*The Reno Creek ISR Project
Campbell County, Wyoming*

**Revised RAI Response Package:
Technical Report**

December 2014

Petrotek
10288 West Chatfield Ave., Suite 201
Littleton, Colorado 80127-4239 USA
303-290-9414
www.petrotek.com

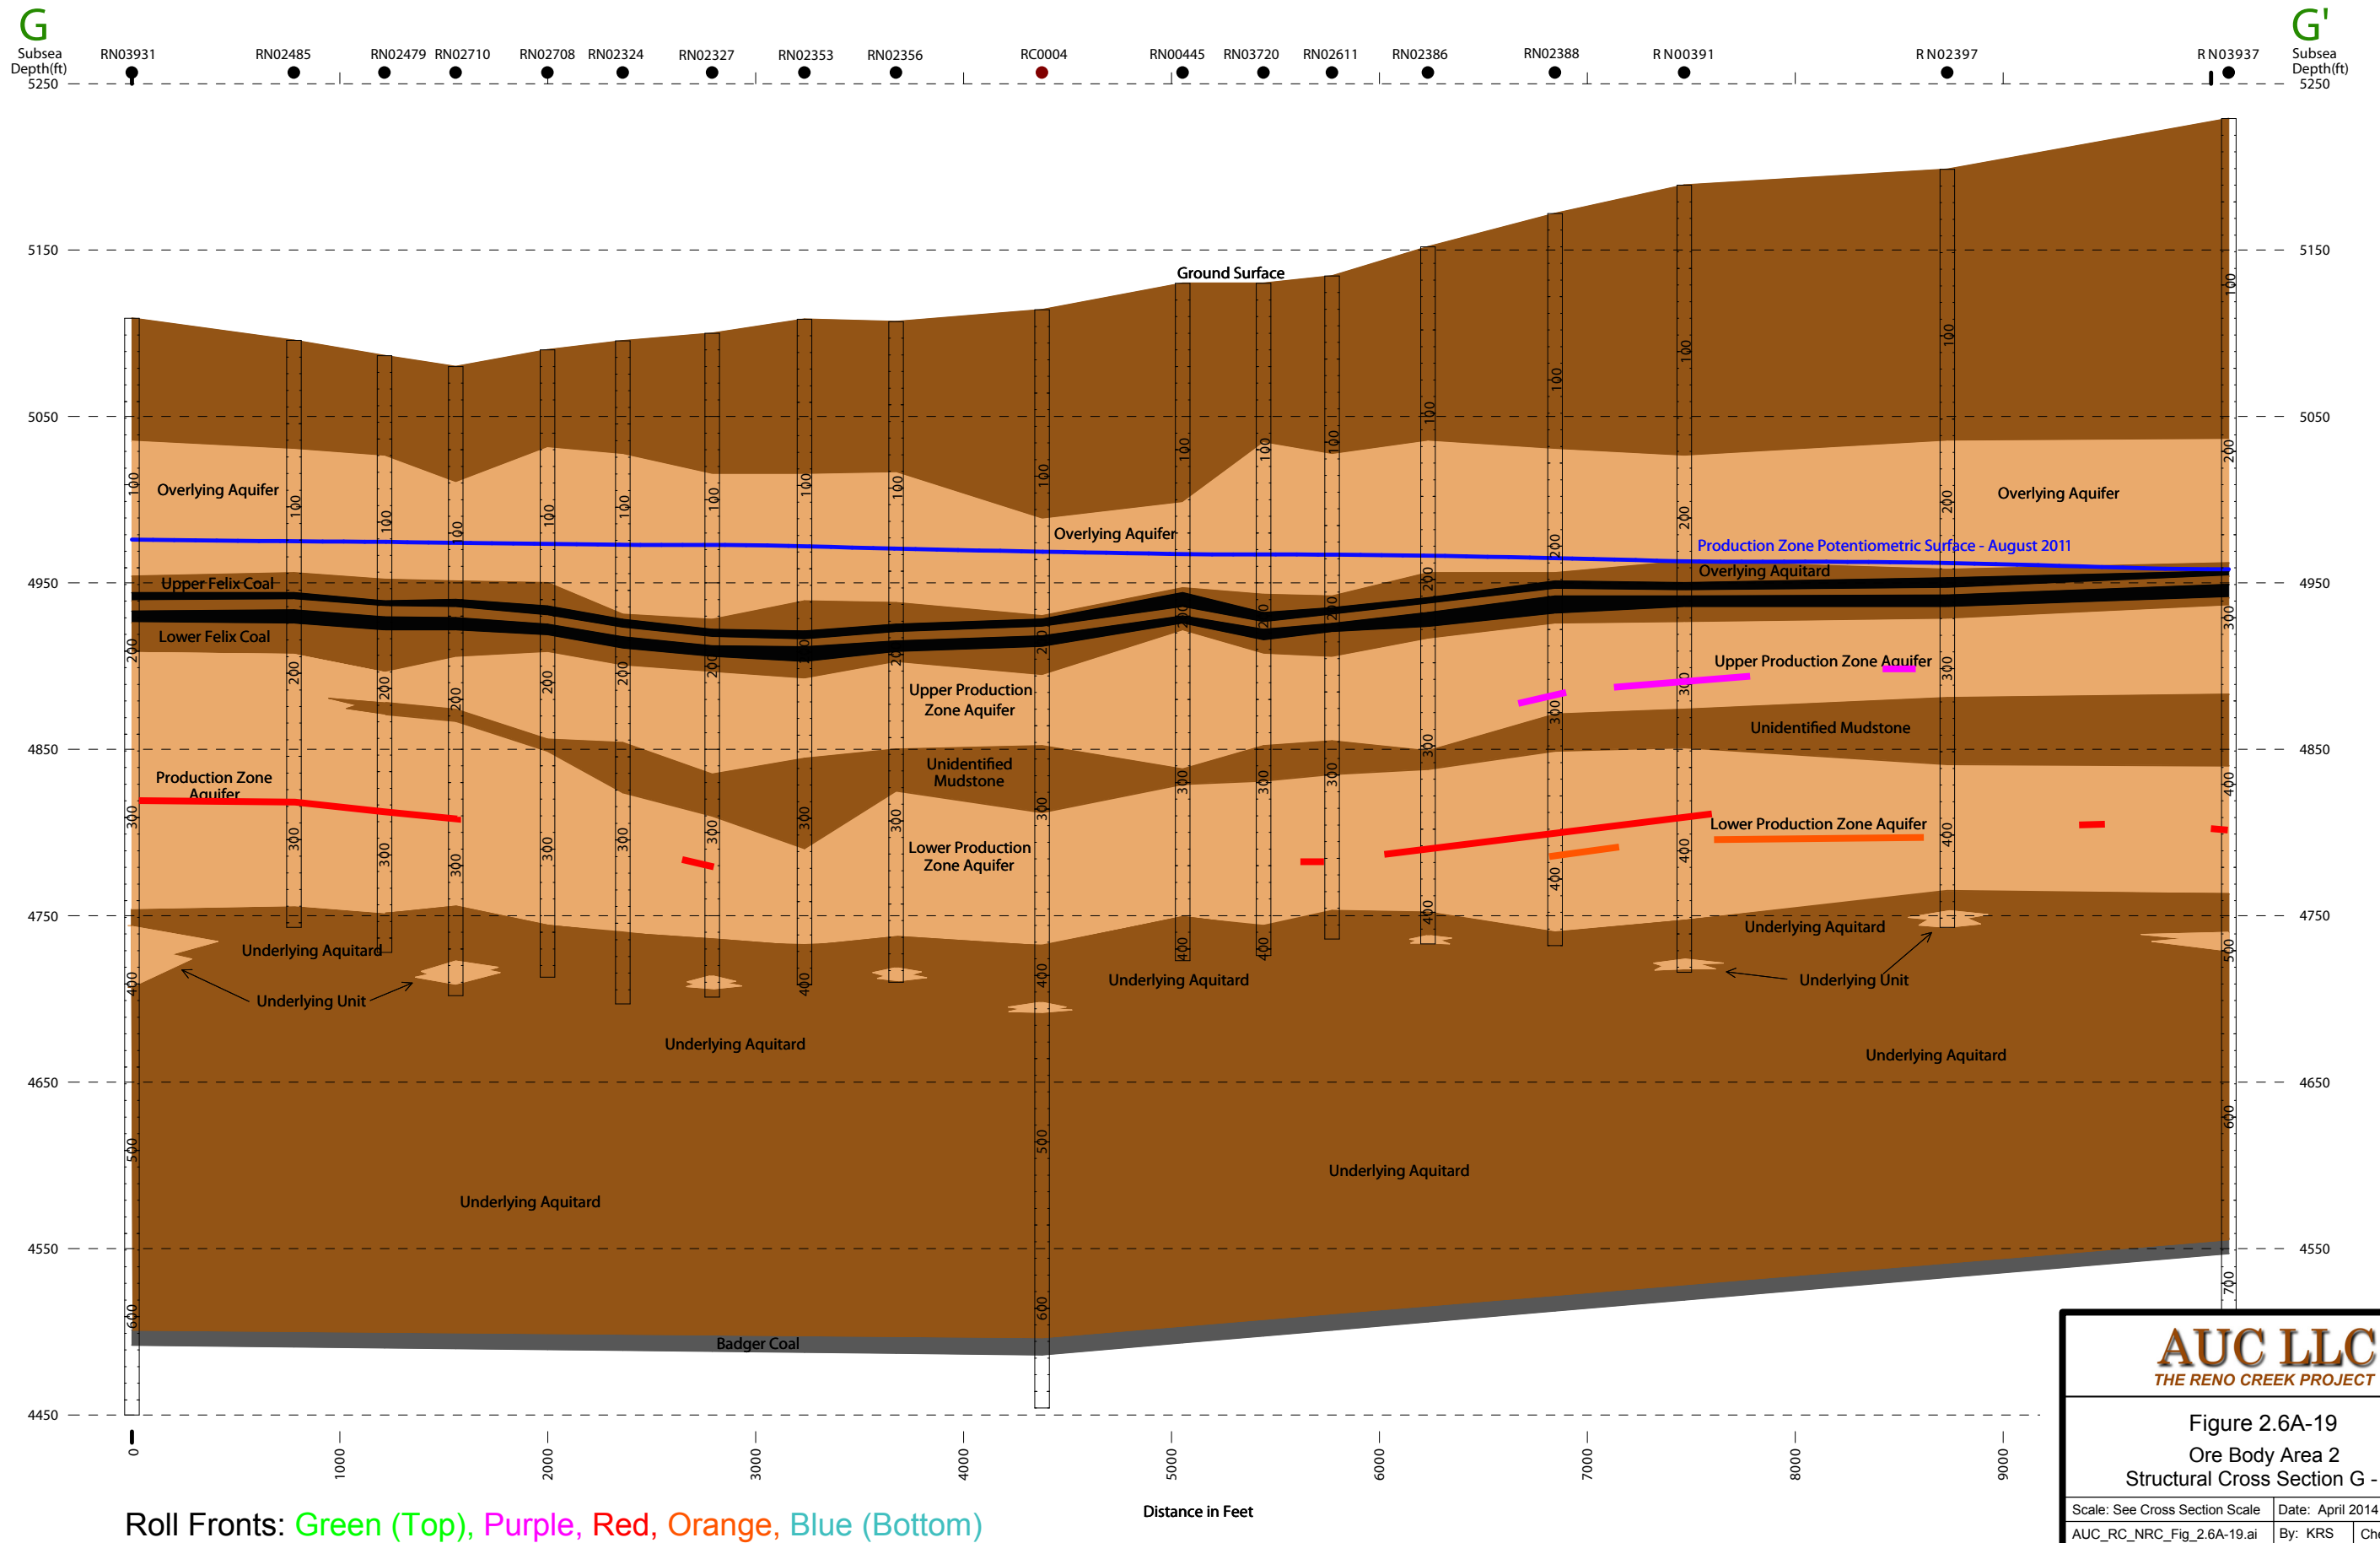
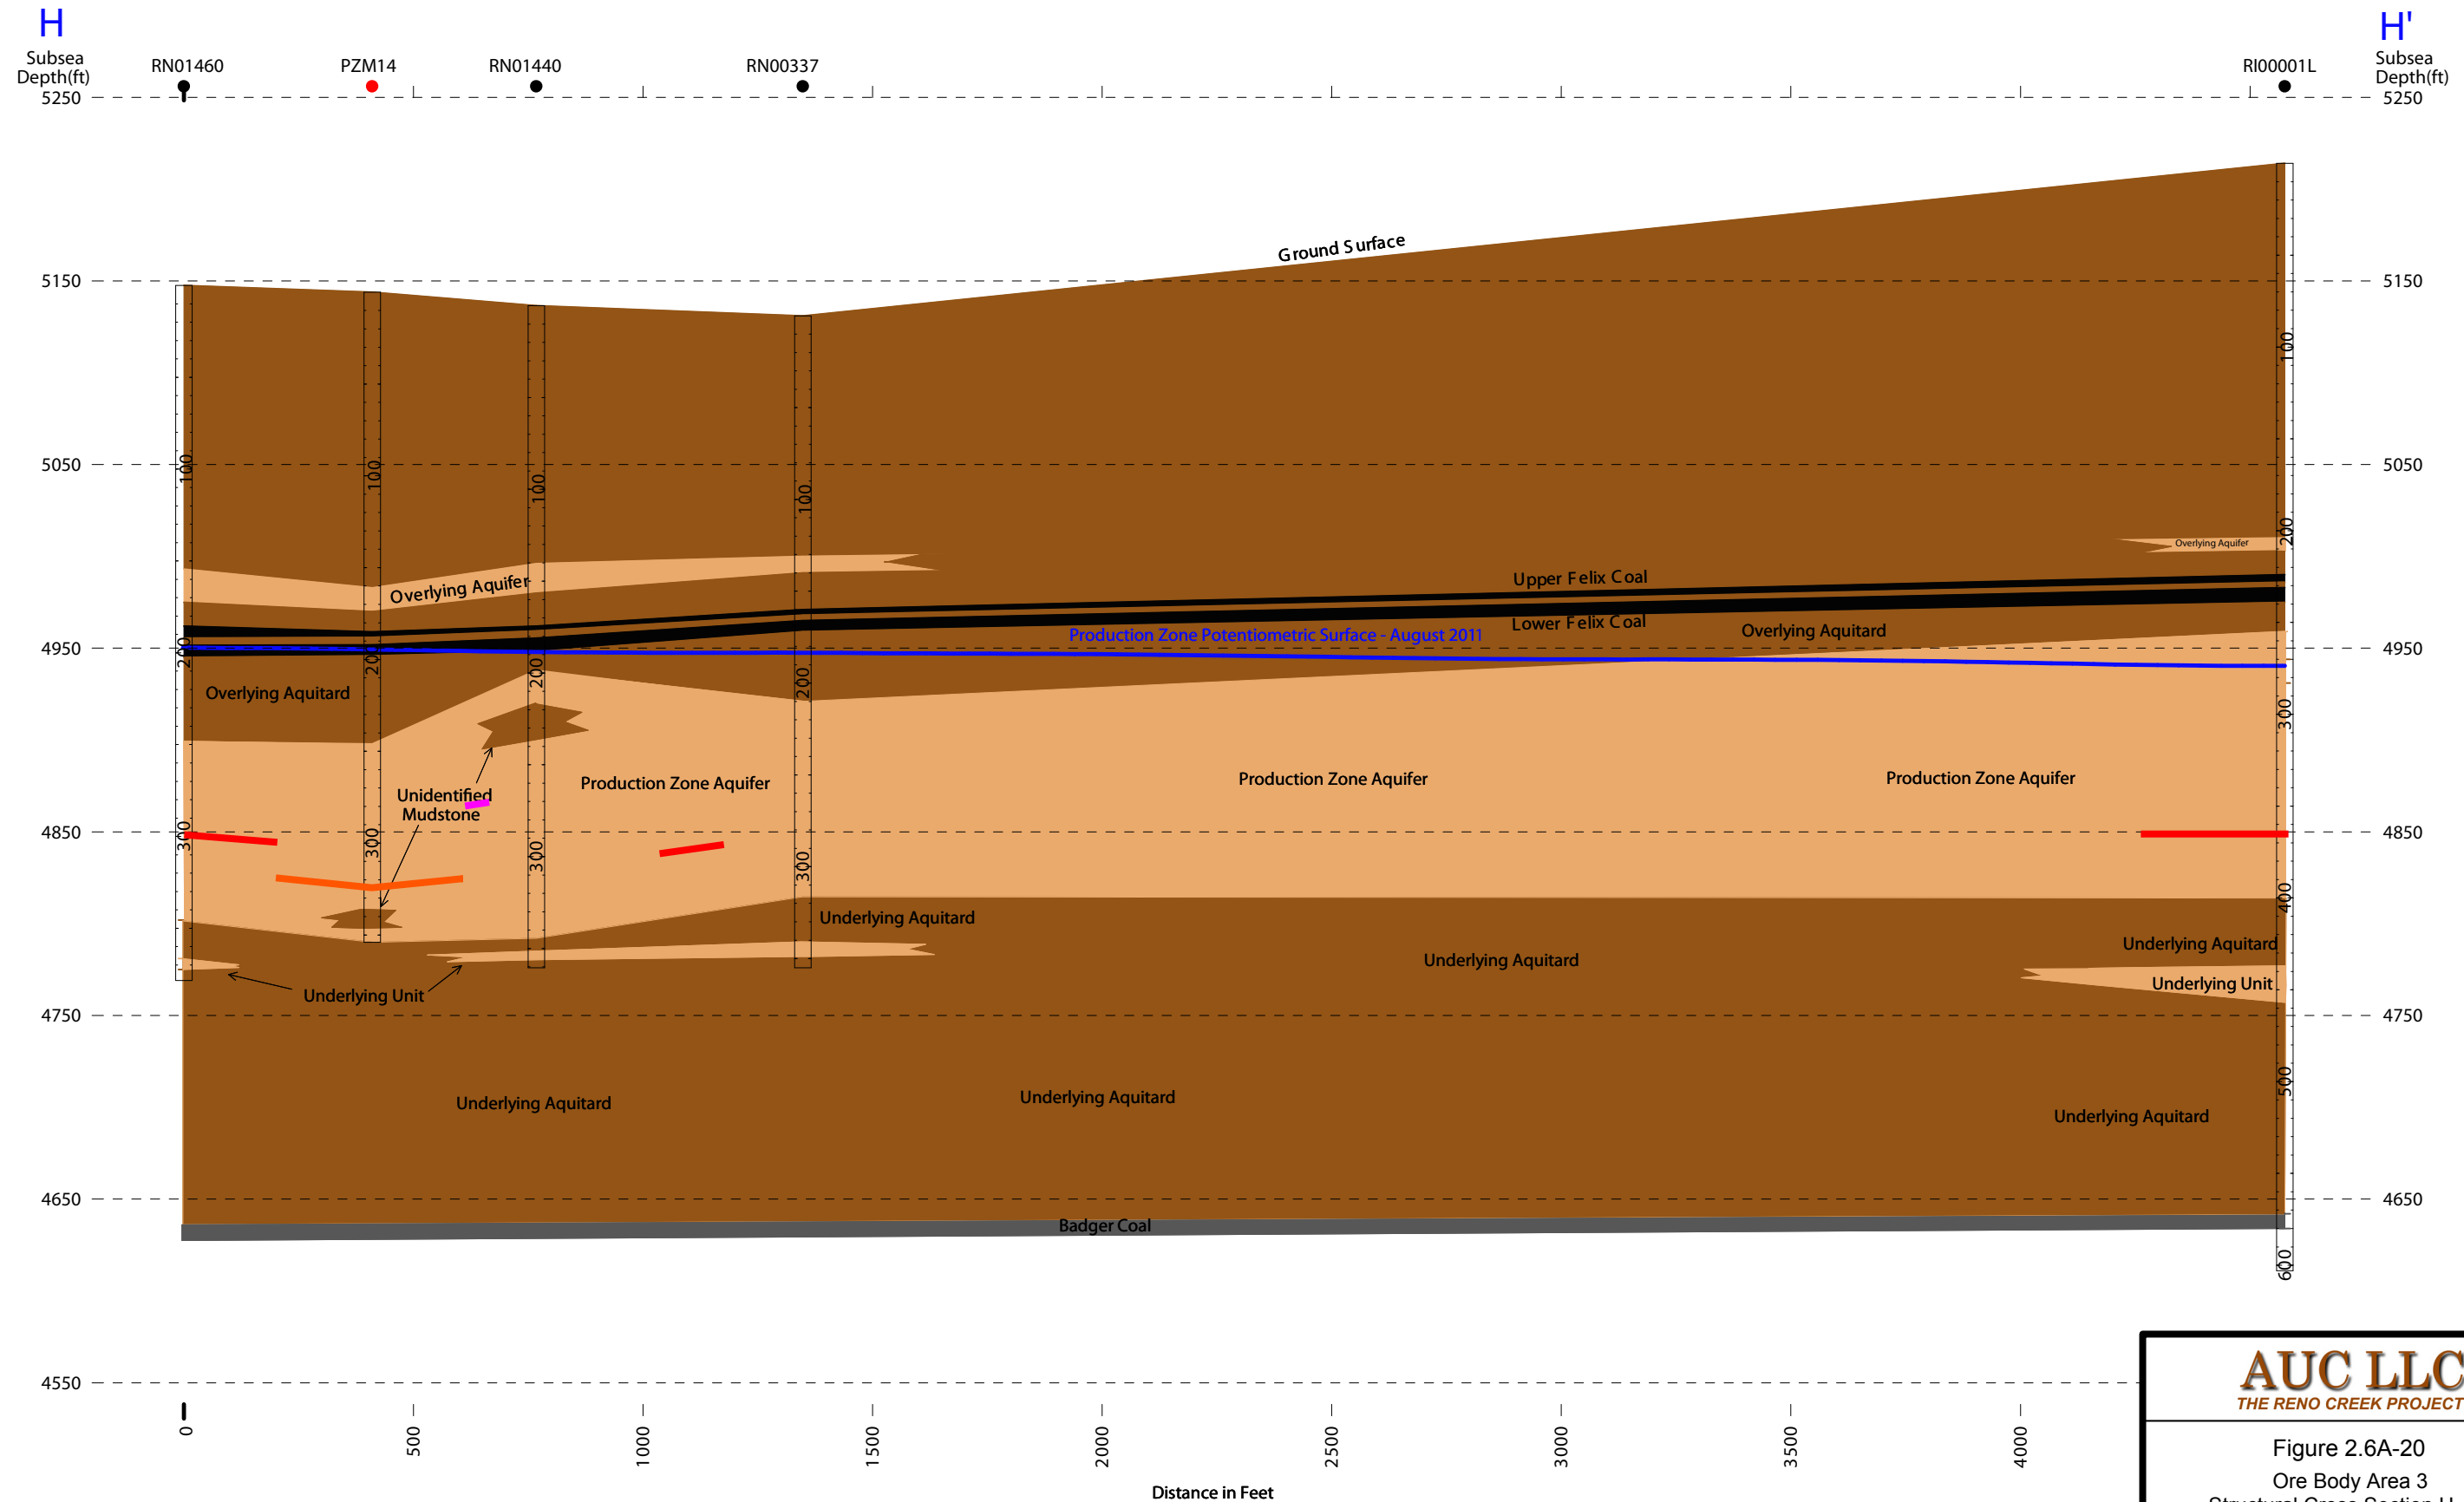
- a) Please provide mapping (including depicting the ore body on the cross-sections) that demonstrates the ore trends including the oxidation and reductions zones.*
- b) Please clarify whether or not Figure 2.6A-17 displays all ore-trend labels, including oxidation and reduction zones.*

On Figure 2.6A-27, the application presented a cross-sectional view of a typical roll front; however, the application did not include cross-sectional views of the ore body within the production zone aquifer throughout the project area (e.g., Figures 2.6A-18 through -23).

“At various localities within the Proposed Project area all horizons from the base to the top of the host sandstone (PZA) can be favorable for uranium deposition. However, economically significant uranium mineralization occurs most frequently in the lower half of the PZA. This relationship and **depiction of the ore trends, including oxidation/reduction boundaries is shown on Figure 2.6A-17. Cross sections depicting the vertical stacking of the ore trends are included as Figures 2.6A-18 through 2.6A-23.**”

Figure 2.6A-17 and Figures 2.6A-18 through 2.6A-23 are shown below:
